X 95.013-26

## **Model Solar Mower**

## Rebuilding of 1995 models

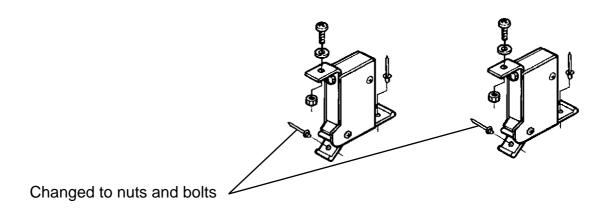
- 6. To improve the fastening of the micro-switch housing (535 03 24-01) in the box (535 03 21-01) the pop rivets have been replaced by two bolts, reference number: **535 03 33-01** and two nuts, reference number: **732 25 12-01**. Only applies to the connection point marked below.
